**THE ABLE MARINE ENERGY PARK DEVELOPMENT CONSENT ORDER 2012  
(PINS REFERENCE NUMBER: TR030001)**

**SUMMARY WRITTEN REPRESENTATIONS OF E.ON UK PLC  
(UNIQUE REFERENCE NUMBER: 10015527)**

Scale:	1:40@A3	Drawn:	J Harris	Checked:	PMS	Approved:	PMS
Date:	26/04/2012	Date:	26/04/2012	Date:	26/04/2012		
Drawing No.:	AME - 03033	Revision:	B

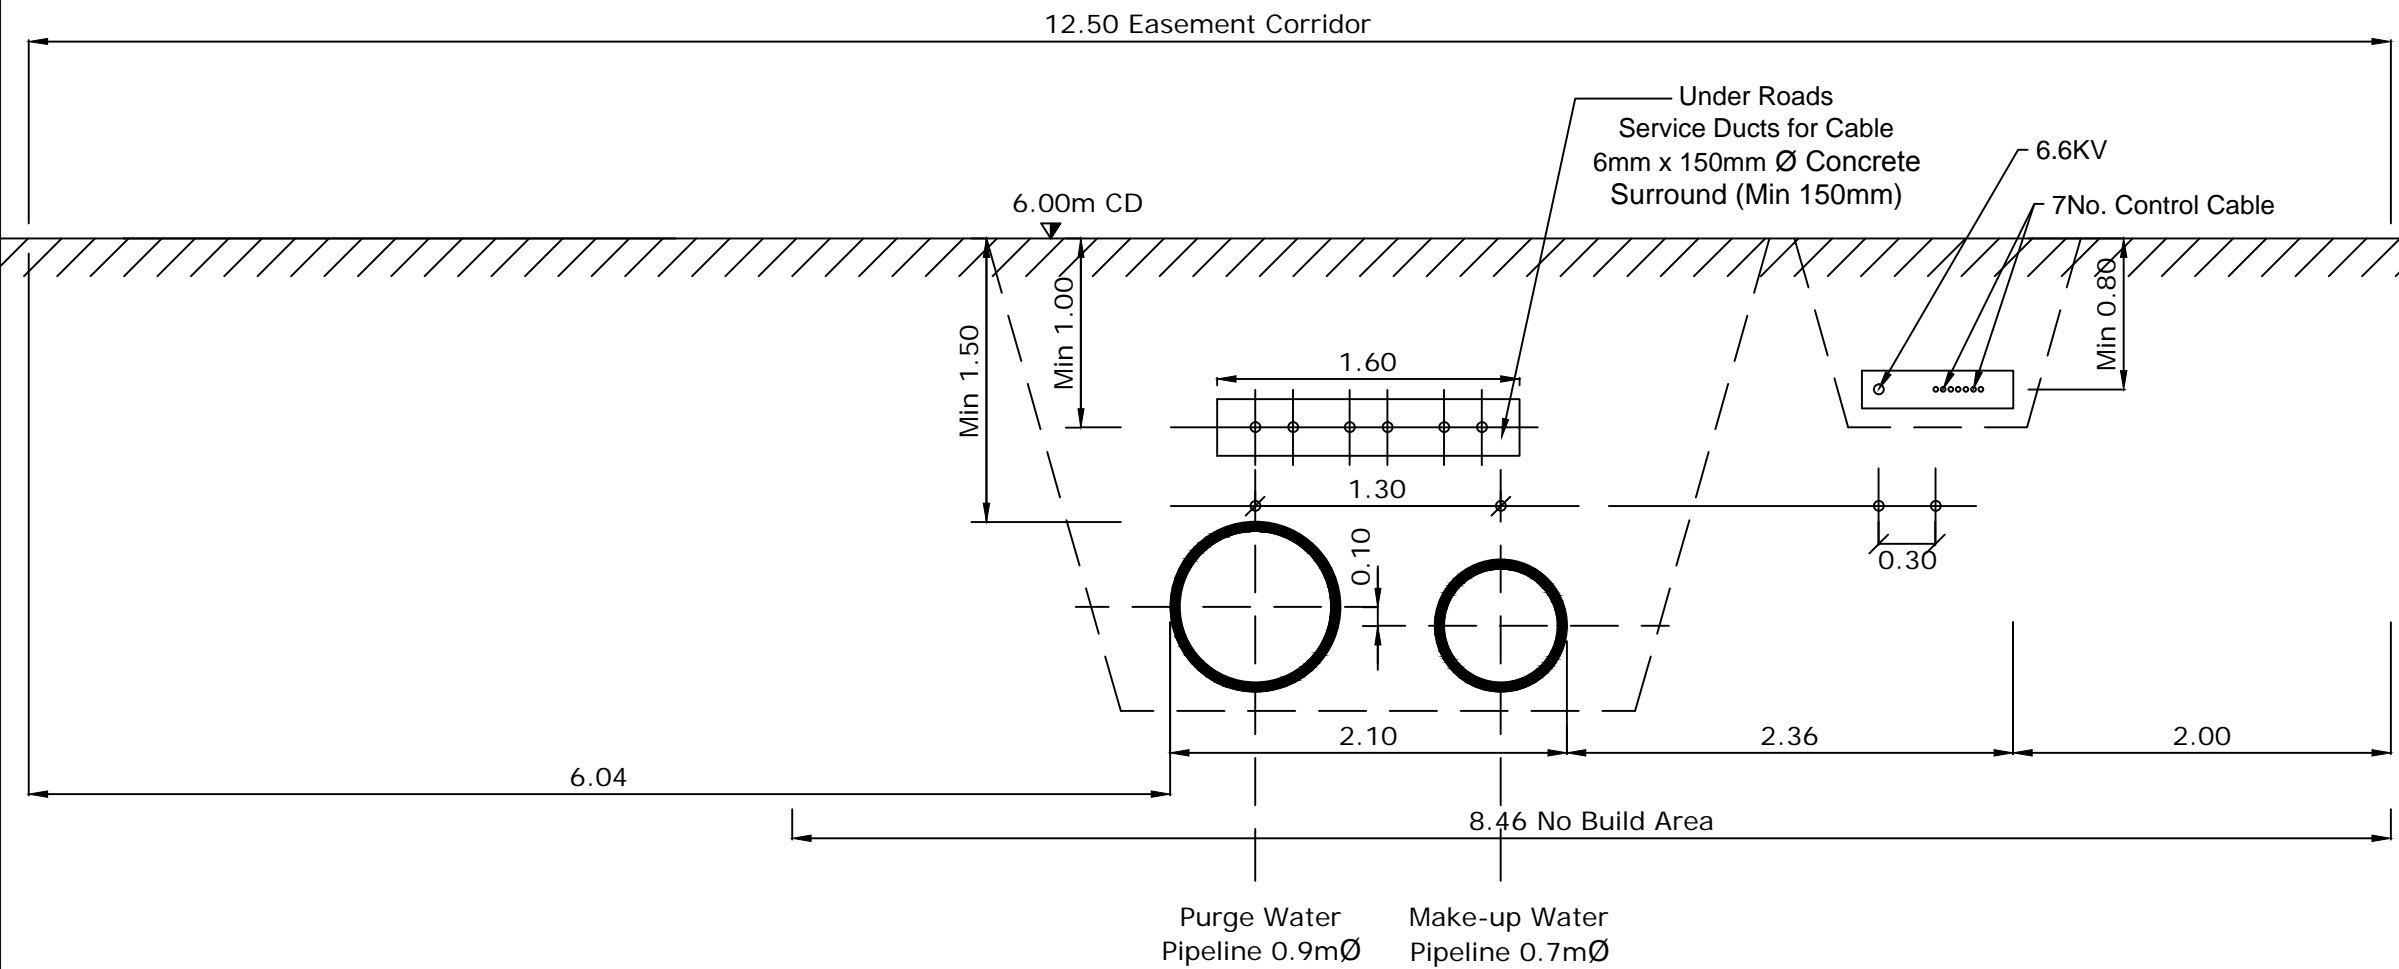
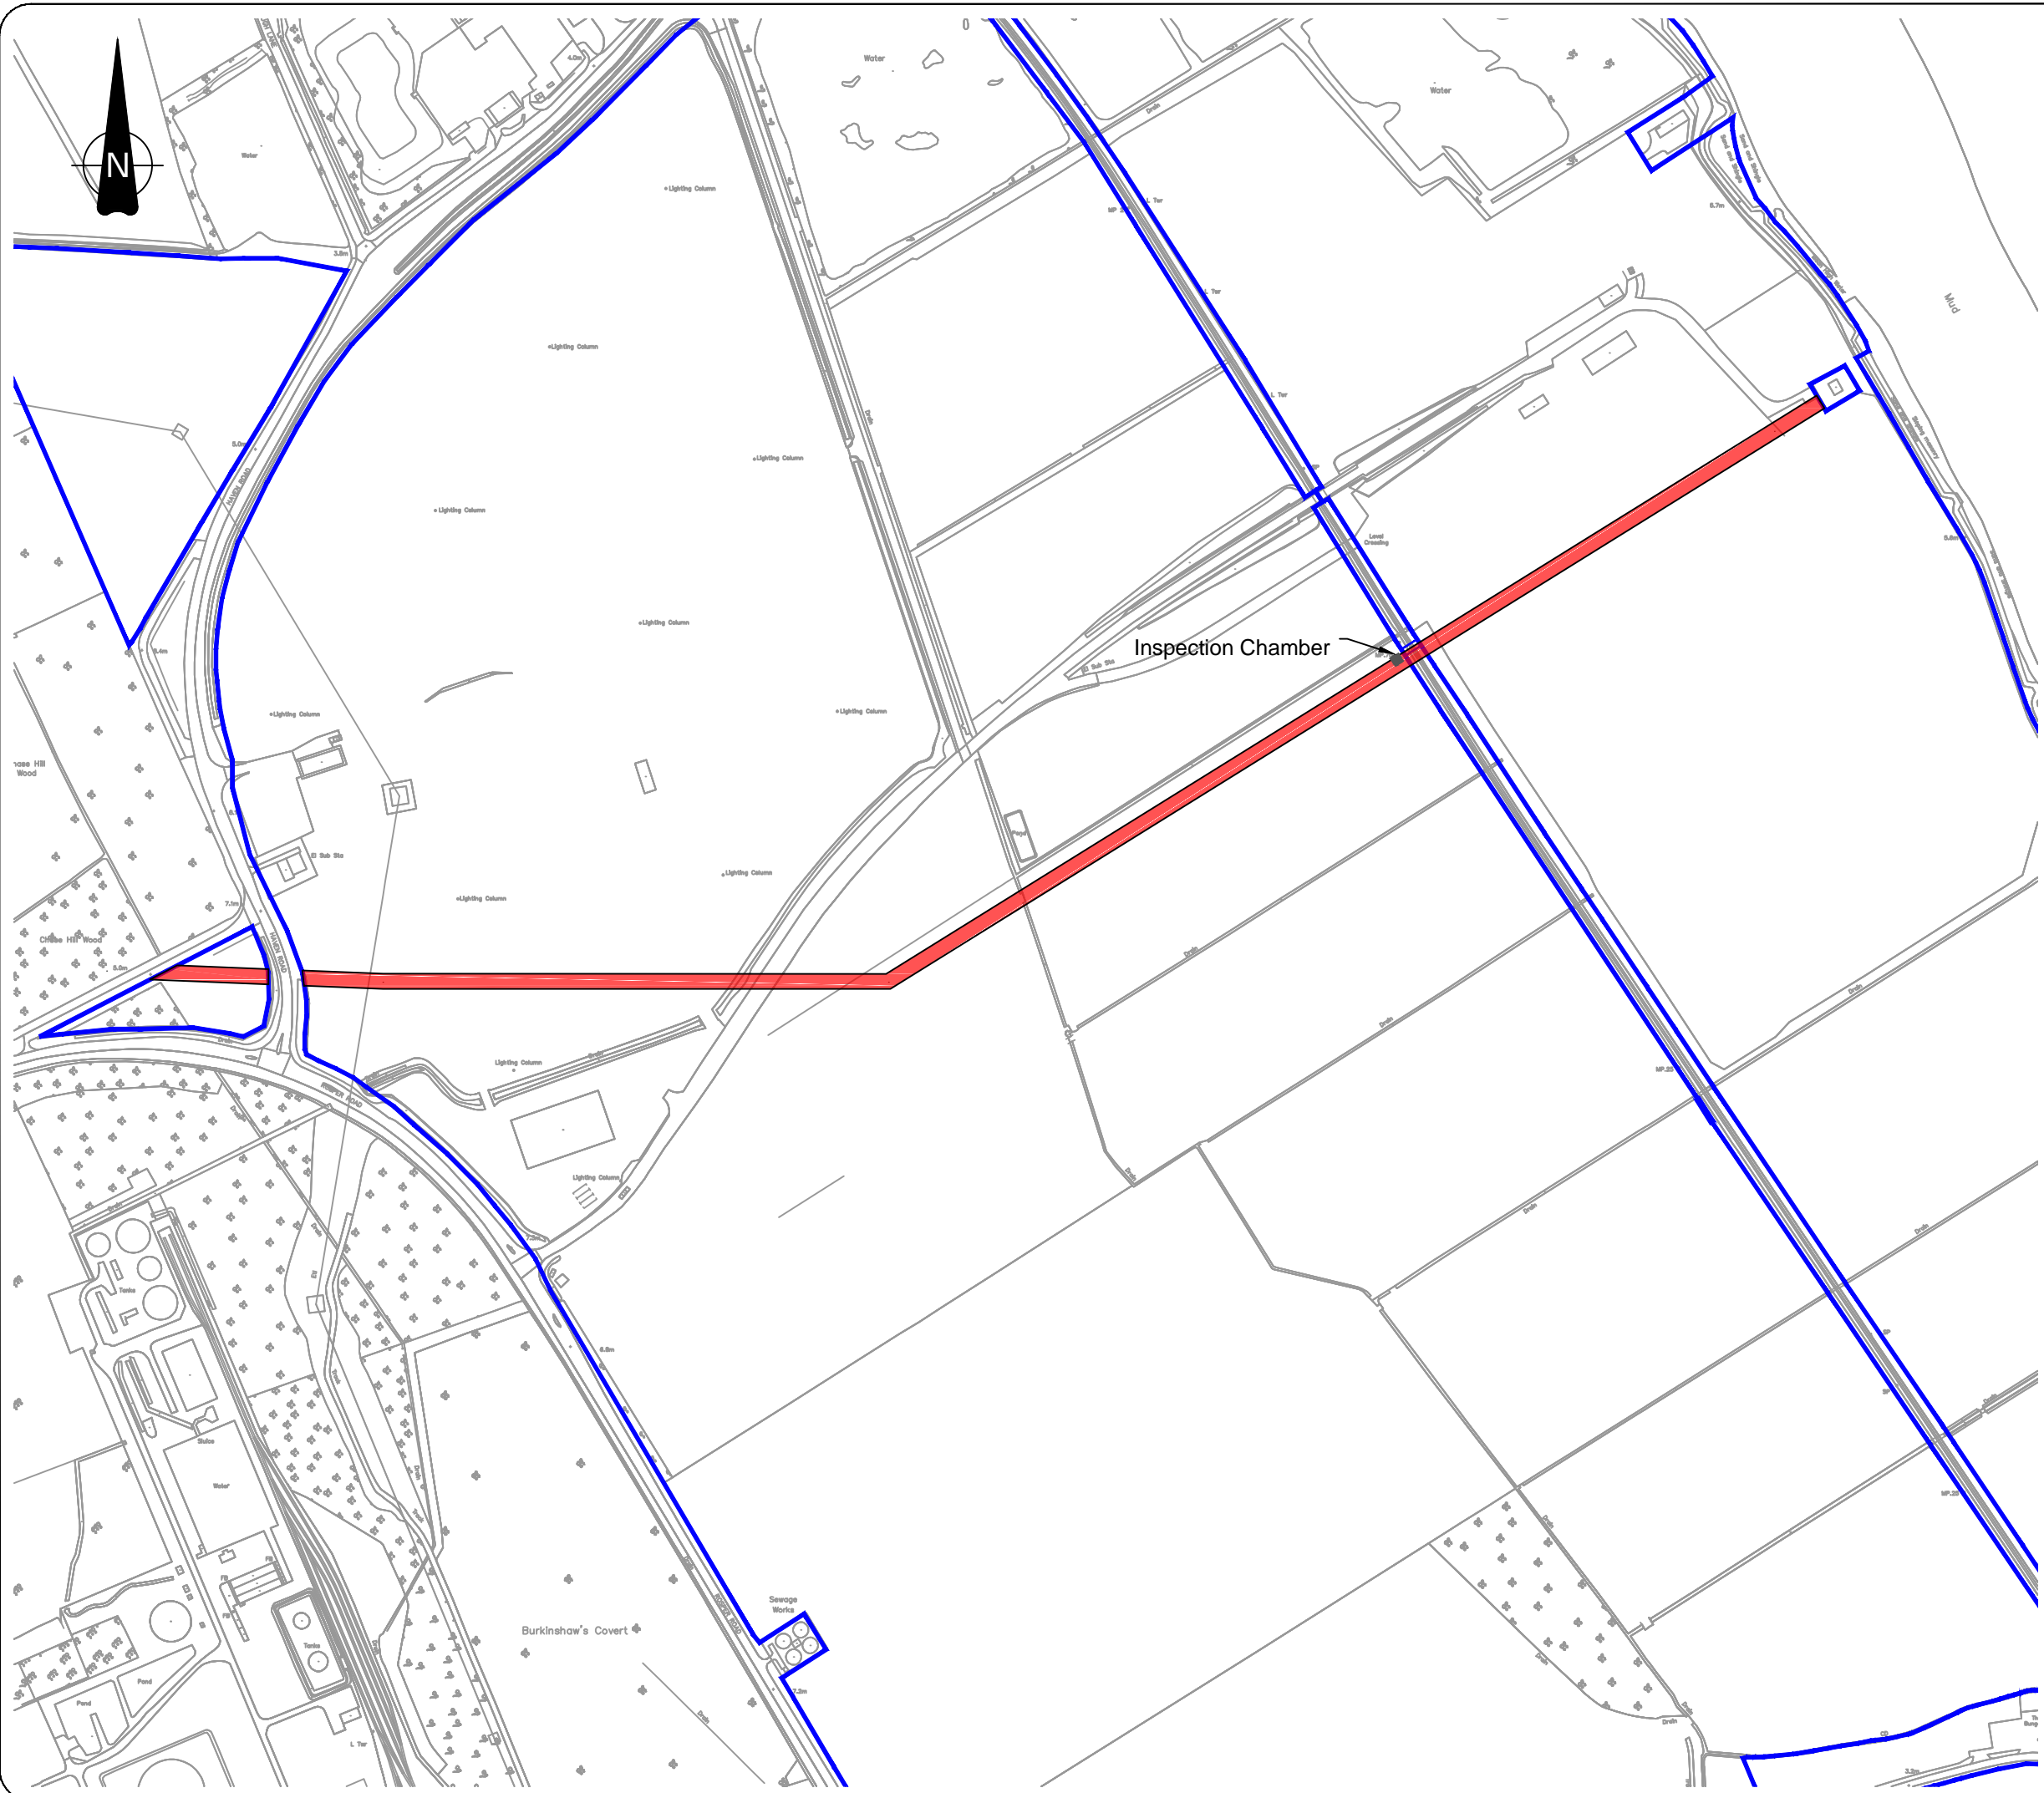
- 4.8 On 17<sup>th</sup> May 2012, the undertaker provided two plans in an e-mail to E.ON : AME-03033 B 'E.ON pipeline typical section' and AME 08093 C 'E.ON AMEP Easement corridor'. This e-mail and drawings proposed a 12.5m easement corridor, again without any explanation as to how workable this might be for E.ON in practice. These drawings are included within **Appendix 5**.

**Drawings provided by the undertaker on 22 June 2012**

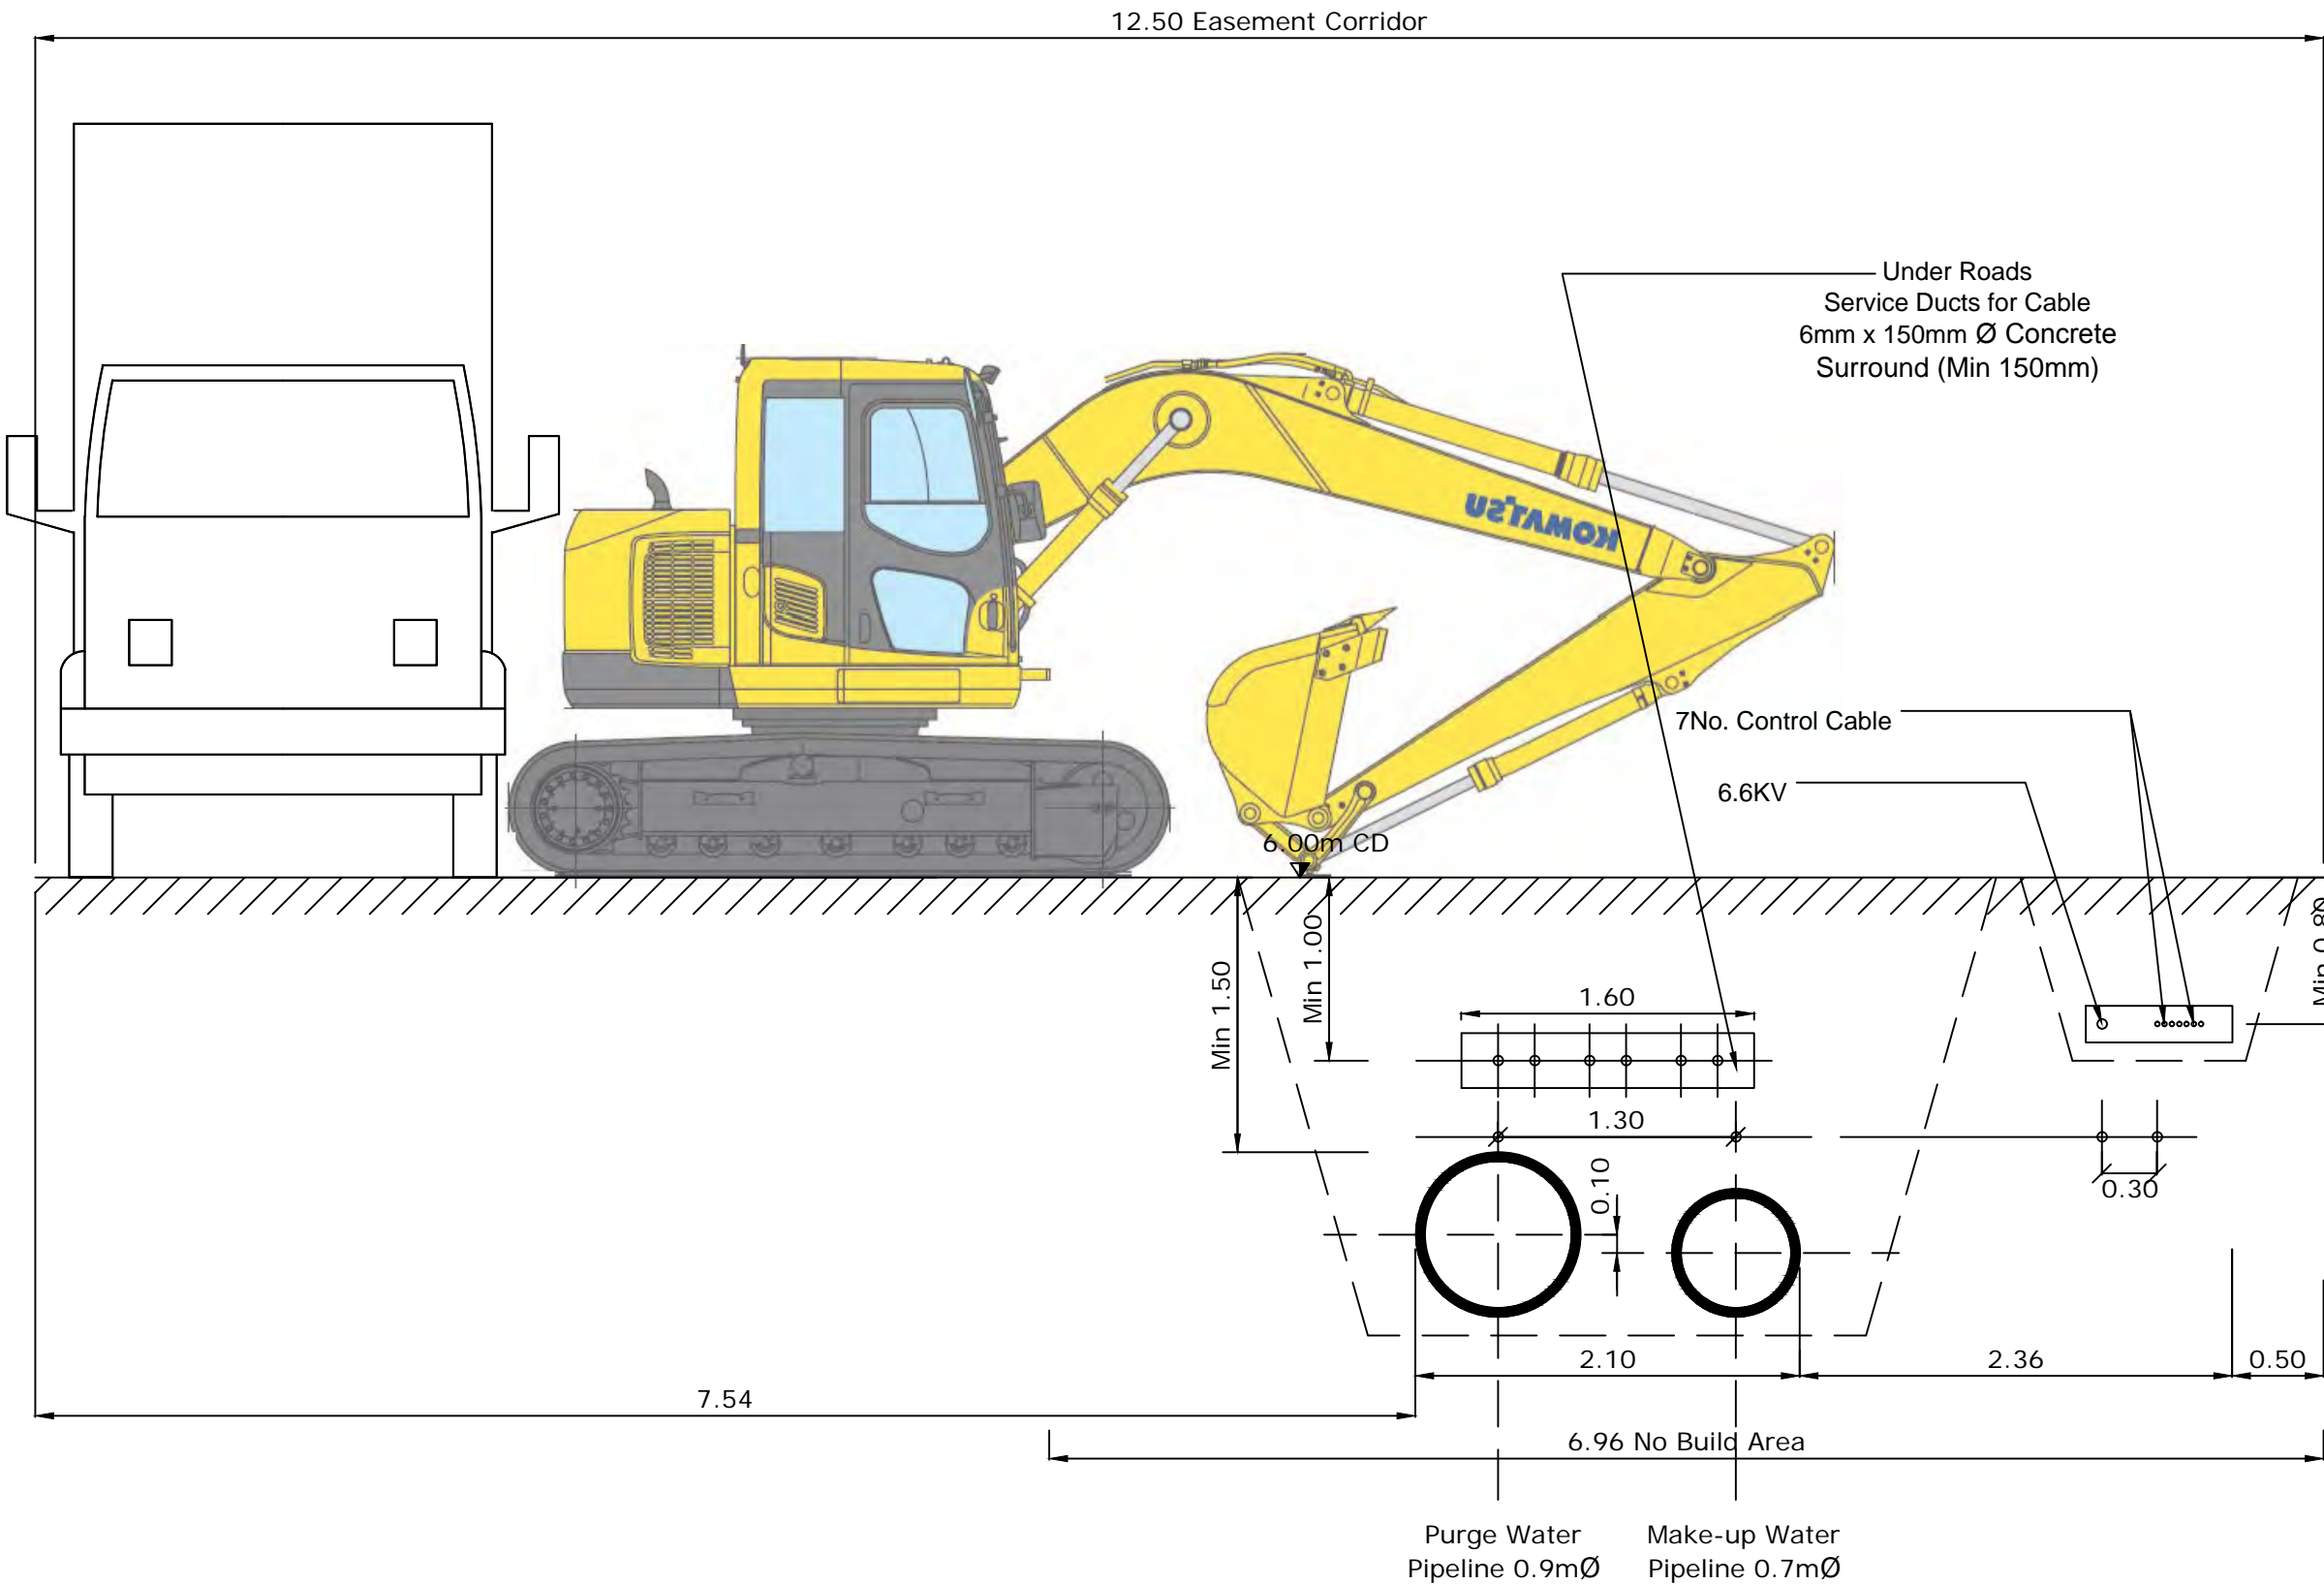
- 4.9 Until Friday 22 June 2012, the undertaker had failed to provide E.ON with any justification of how a 12.5m easement would work. On that date, drawing AME-03033 Rev C was received which superimposed a schematic of a lorry and a JCB on to the aforementioned E.ON pipeline typical section drawing. This drawing is included within **Appendix 6**. No further information was included to explain how this was arrived at and how practical and safe this working arrangement might be, and E.ON's view was that it appeared to represent an unworkable and unsafe practice.
